# 16jm Ad Hoc Group Recommendations on High Level Constructs for 16m Relay Frame Structure

IEEE C802.16m-08/499

For informing TGM about the discussions that took place in the 16jm AHG regarding frame structure constructs.

# Slide 7 from 16mRelayFS-AHG.pdf: Multiplexing Legacy RS and 16m RS in UL

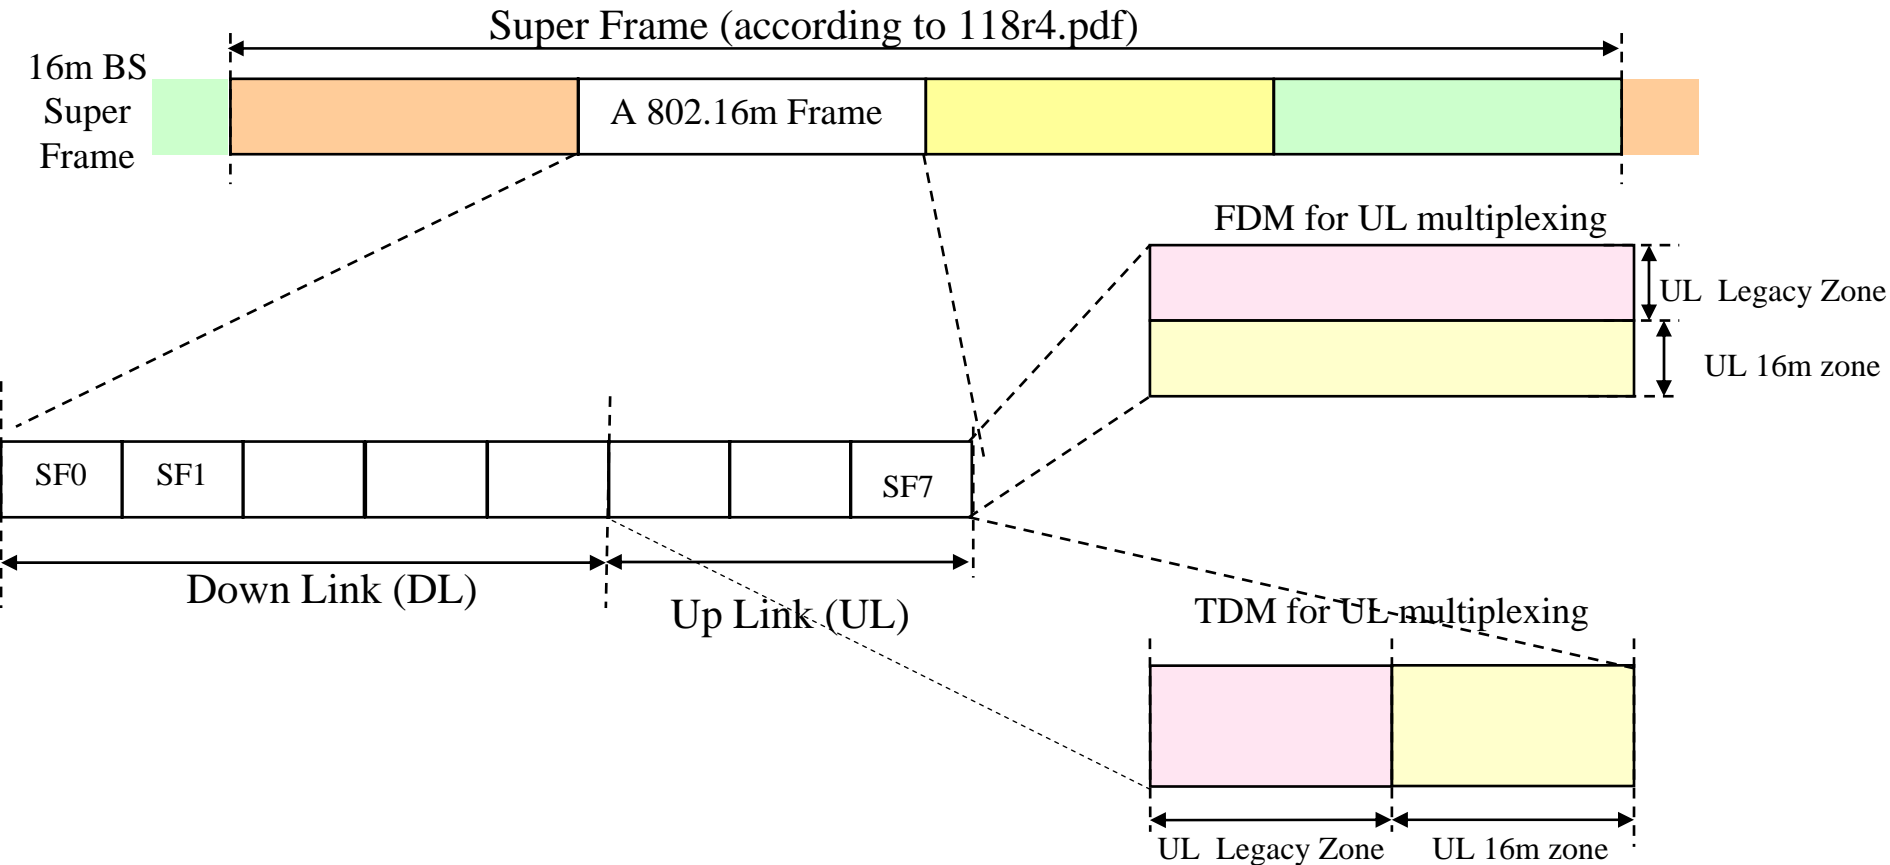
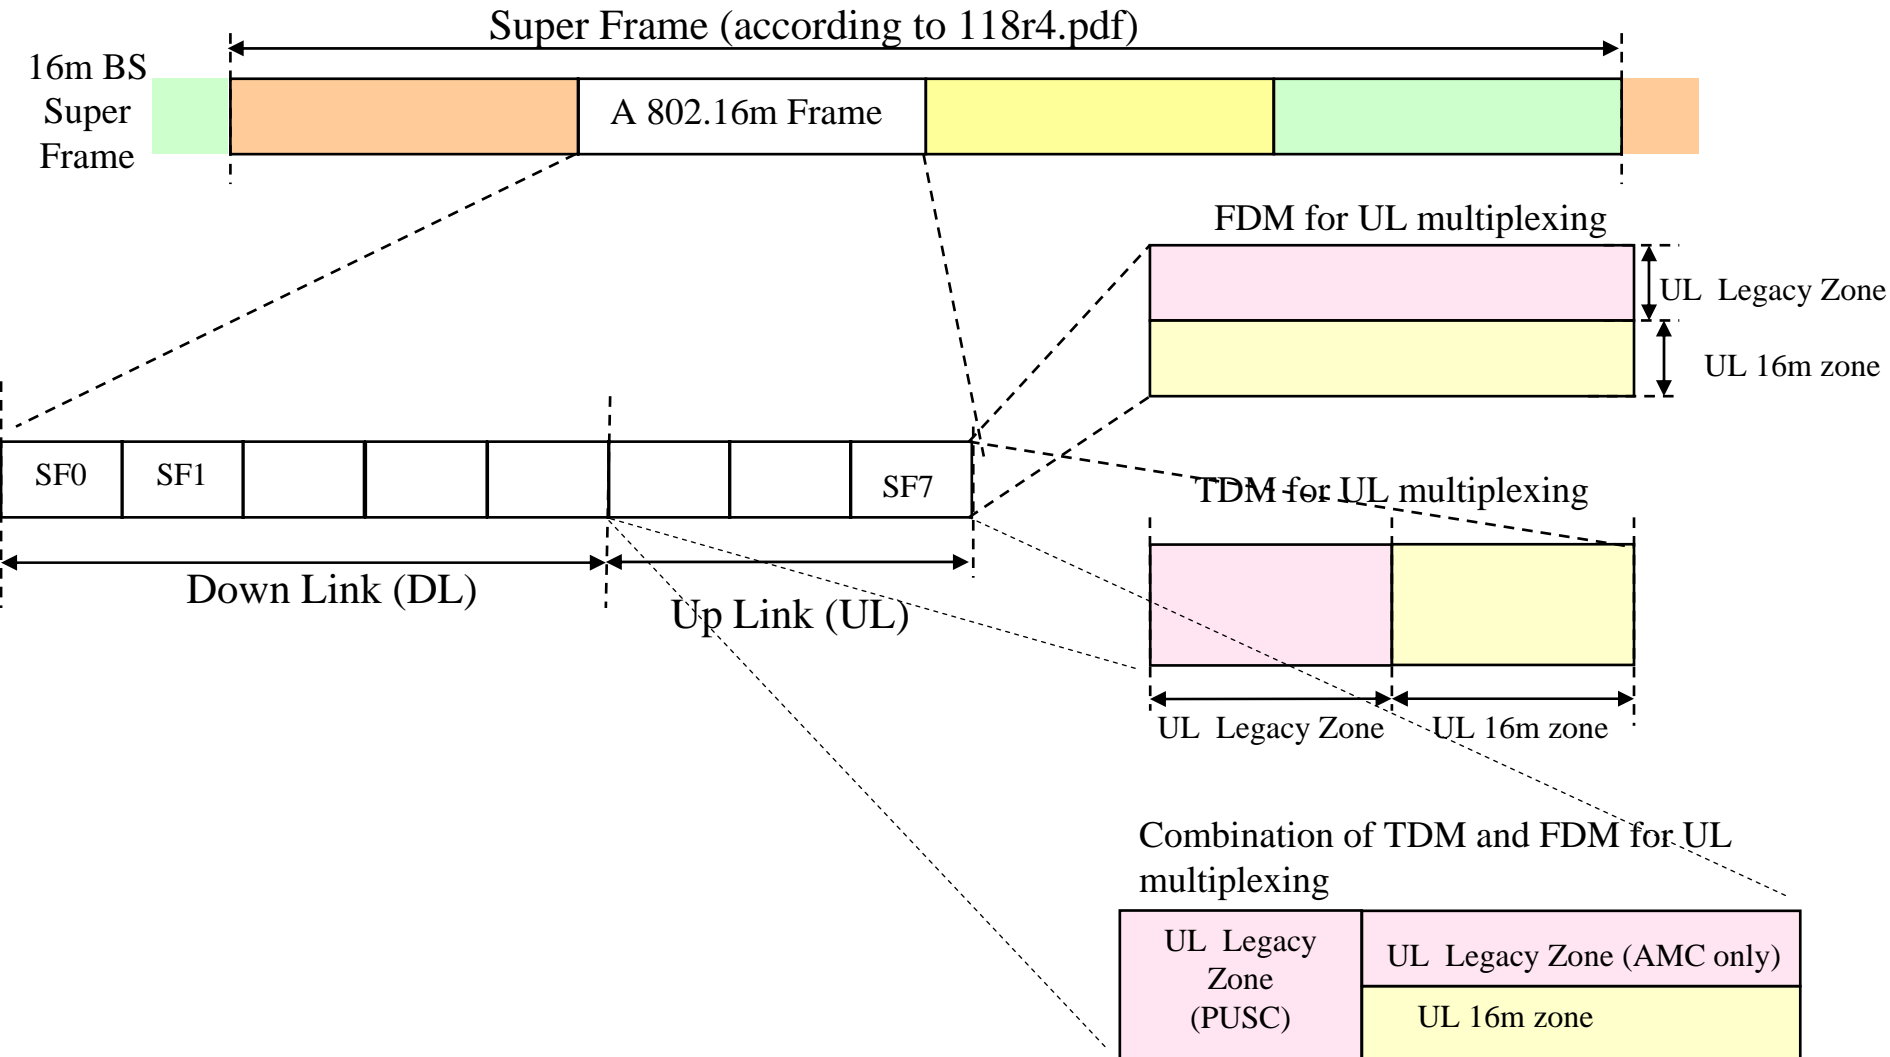
- 2 comments:
  - Nortel:
    - Replace the text on slides 6 and 7 with the following text:
      - A 16m BS that supports legacy relay station shall communicate with the 16j RS in the legacy zone. A 16m BS that supports 16m relay station shall communicate with the 16m RS in the 16m zone.
  - Intel:
    - Modify slide 7 as follows: See next slide

- New SDD text for slides 6 and 7 (Proposed):
    - Insert in SDD Section 11.4.5, page 22:
      - A 16m BS that supports 16m relay stations shall communicate with the 16m RS in the 16m zone. The 16m BS shall multiplex the legacy zone and the 16m zone using TDM in the DL. In the UL, the 16m BS should support TDM as well as FDM for multiplexing legacy zone and the 16m zone.

Fig. xa Frame Structure for TDD Relay

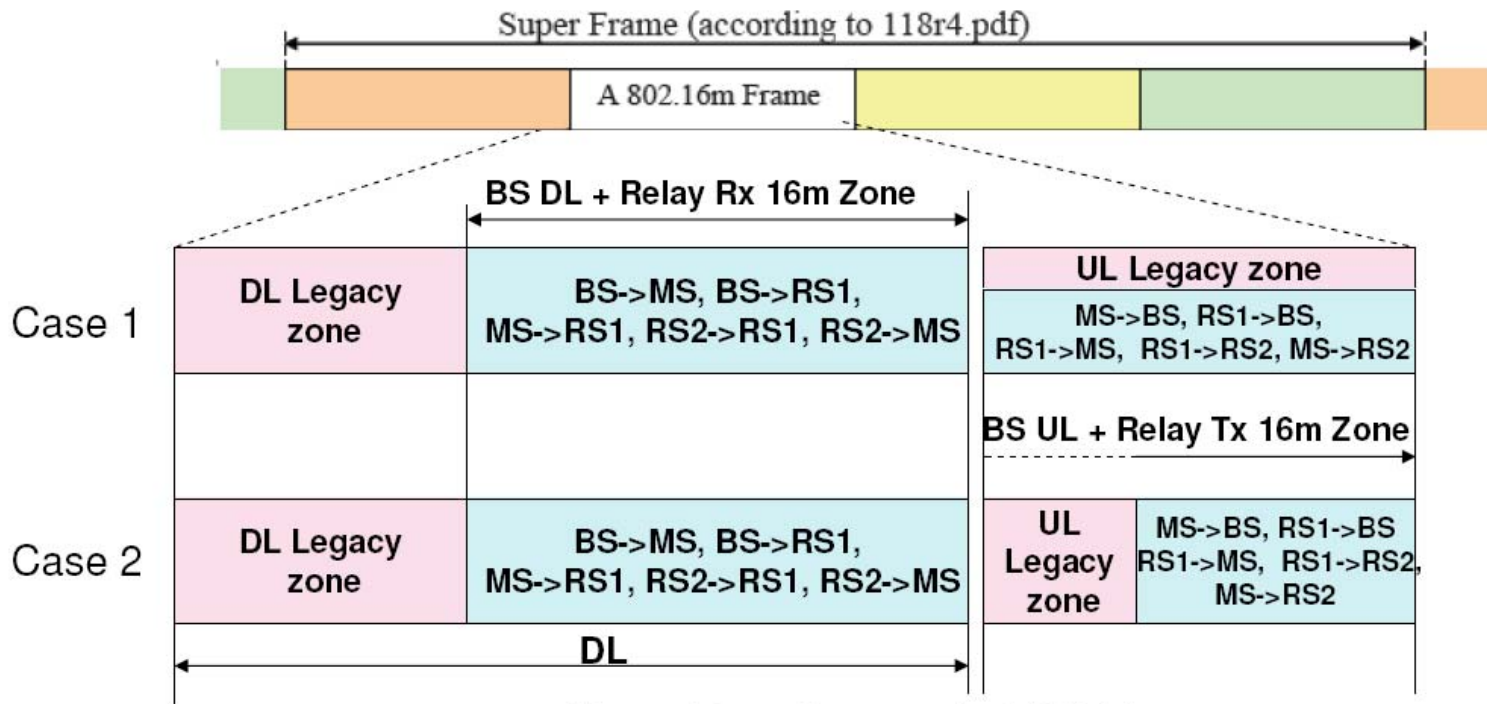
- [Option 7: Alvarion] In the DL 16m zone, inserted in BS DL sub-frame, the traffic is FDM multiplexed in different Zones based on Relay Rx or Tx operation. In the UL 16m zone, inserted in BS UL sub-frame, the traffic is FDM multiplexed based on Relay Tx operation.

- There is no consensus for the SDD text on slide 9. Several comments were received.
- The received inputs can be categorized. Proposed modifications to the text aimed at:
  - capturing >2 hop relay support.
  - Facilitating bi-directional transmission to (or receiving from) super ordinate and subordinate stations at the same time.
  - Enabling simultaneous Tx/Rx to subordinate station and Rx from superordinate station (full duplex relaying).
  - 16j RS behavior in 16m zone (from 16m BS perspective).
- Most comments indicate that the “sub-zoning” within the 16m zone is rigid (makes it difficult to capture the intended features).
- More discussions are needed to finalize the high level frame structure constructs for the 16m zone.

## Example DL Frame Structure for Case 8

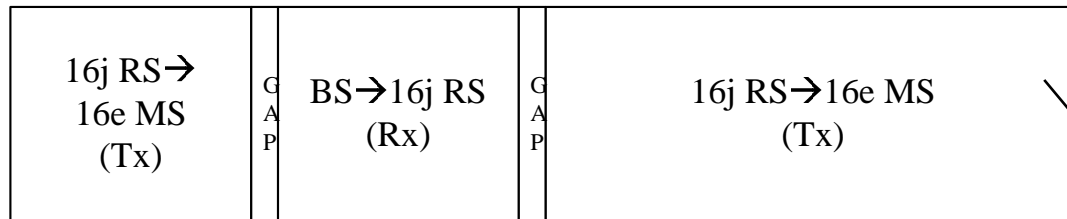
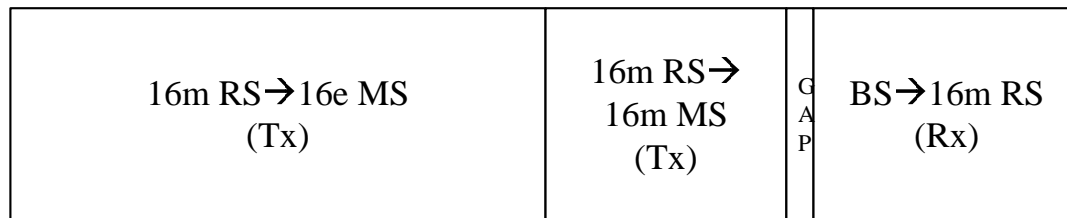
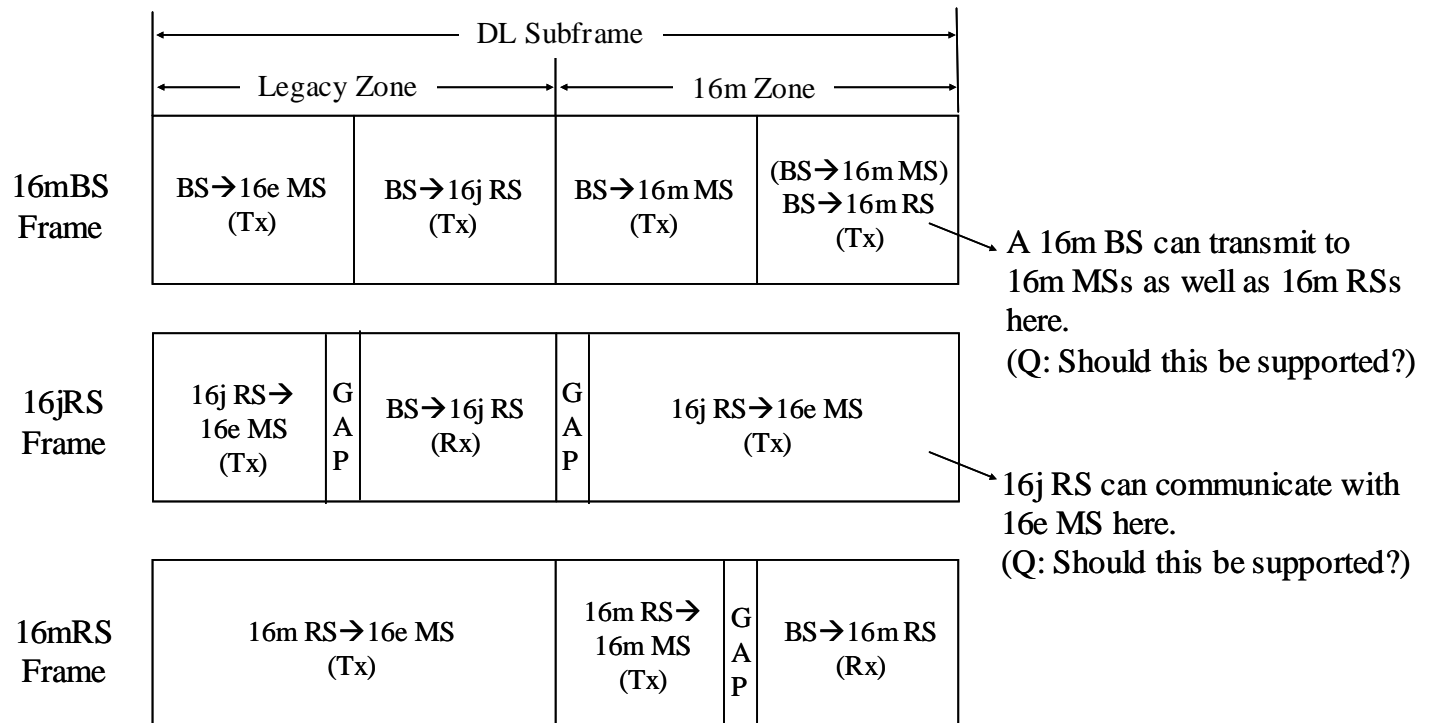
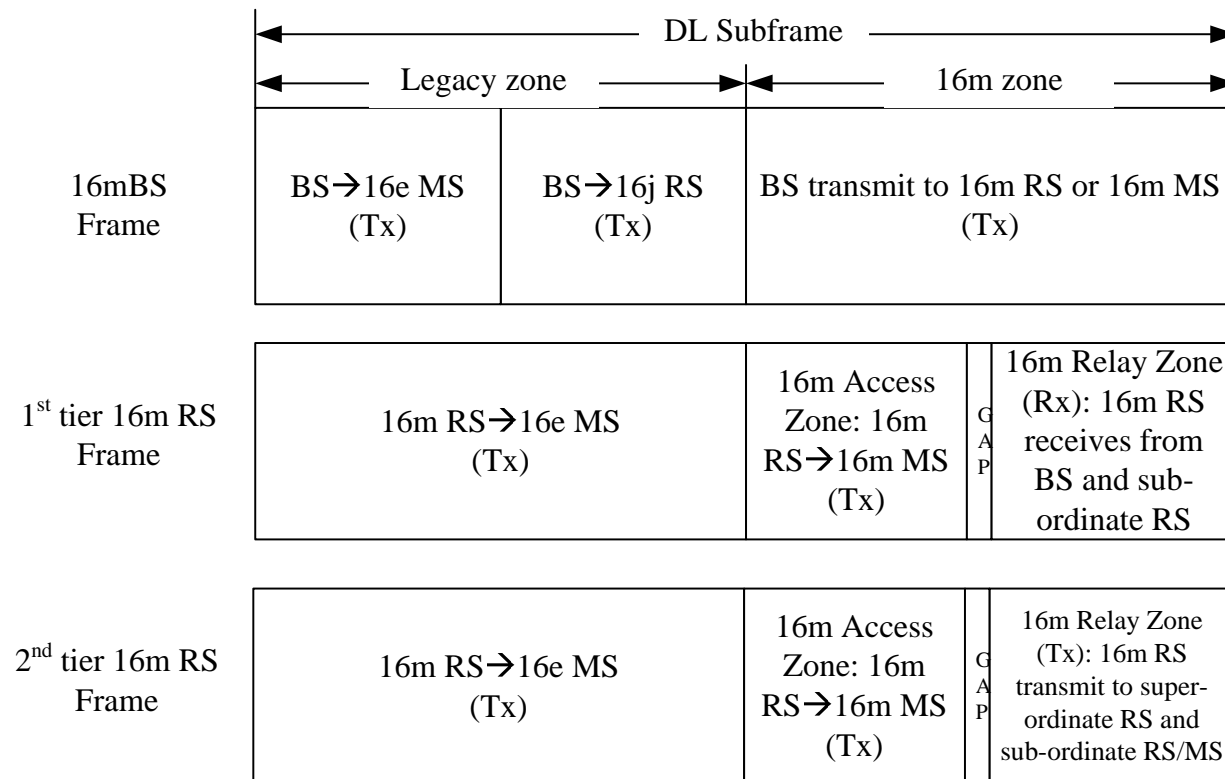
- Interdigital: Yes to 1<sup>st</sup> question
- Samsung: Yes to both the questions.
- LGE: The relative position between 16m access and relay zones is FFS.
- III: The boundaries of relay zones at 16m BS and 16j RS shall be time-

- Nortel: Replace the figure as follows:

- Defer discussion until decision on the basic constructs (Slides 6 through 11 of 16mRelayFS-AHG.pdf) can be made.

## Example UL Frame Structure for Case 8 (TDM)

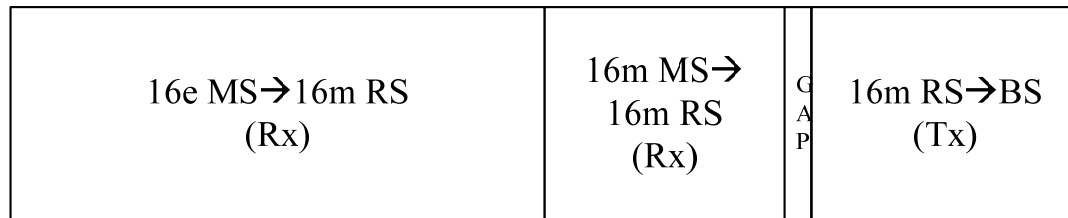
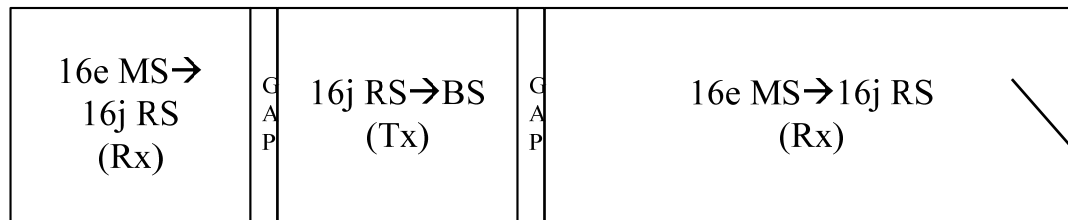
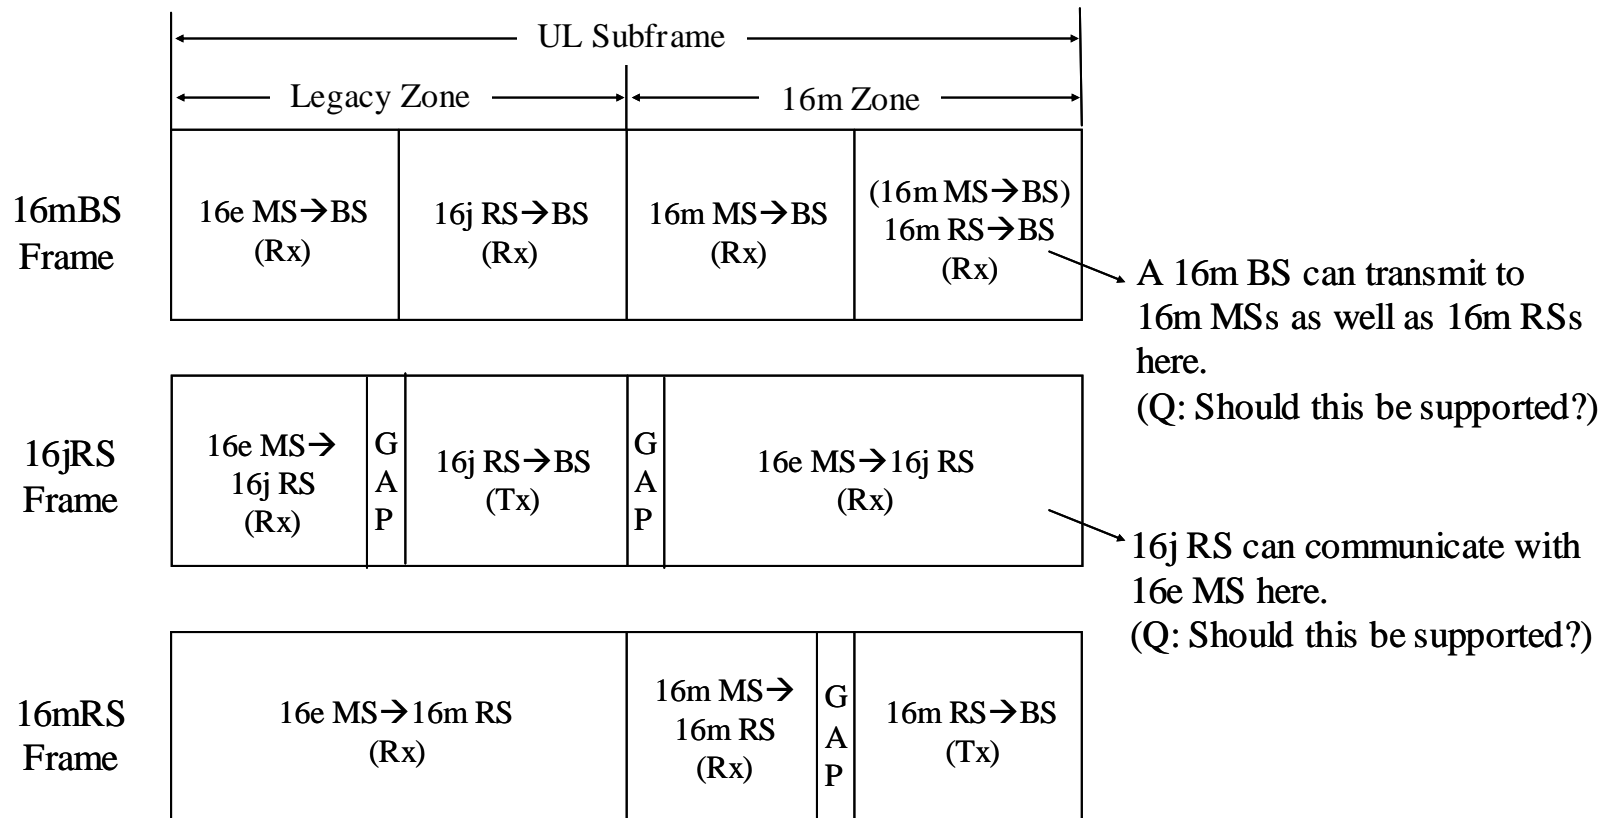
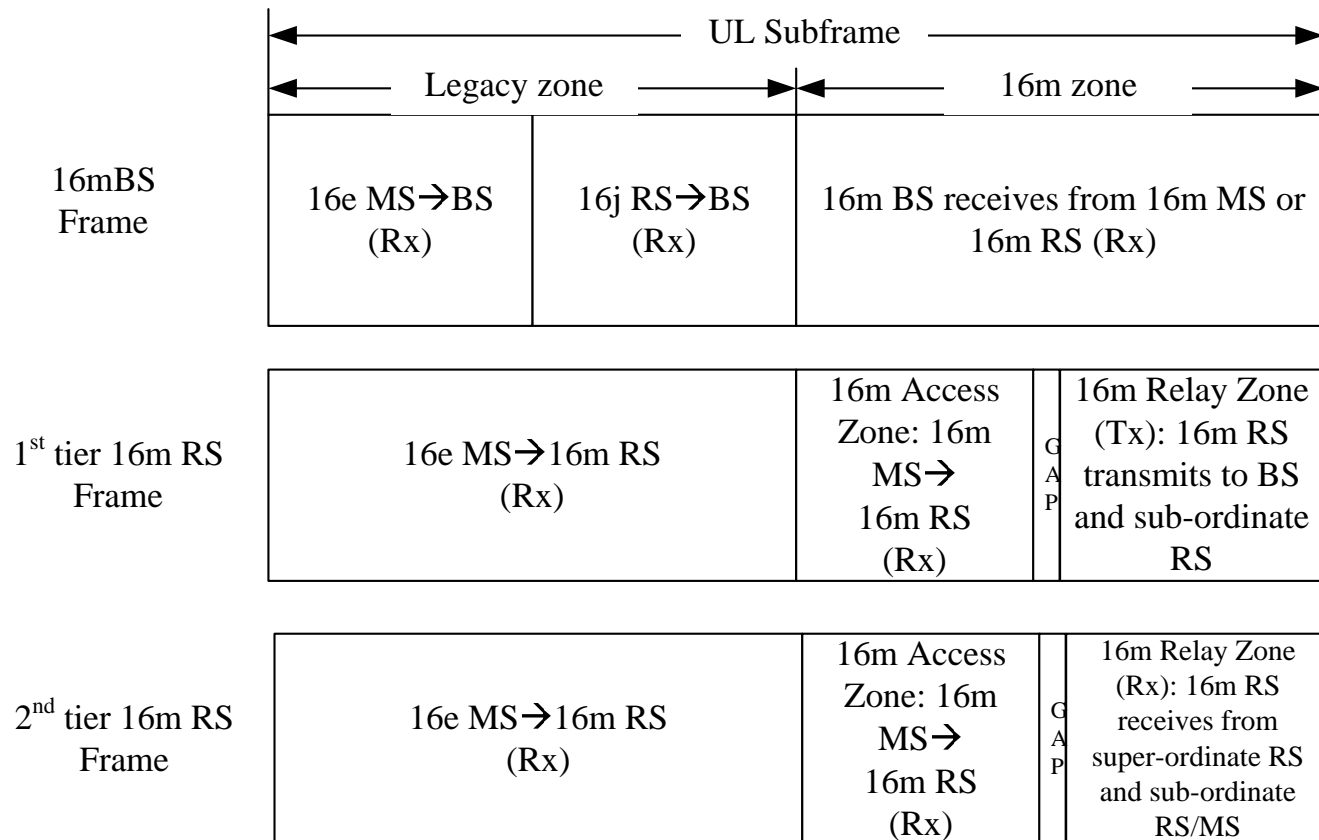
- Interdigital: Yes to 1<sup>st</sup> question
- Samsung: Yes to both the questions.
- III: The sequence of the figures of 16m RS and 16j RS frame structure should be reversed.

- Nortel: Replace the figure as follows:

- Defer discussion until decision on the basic constructs (Slides 6 through 11 of 16mRelayFS-AHG.pdf) can be made.
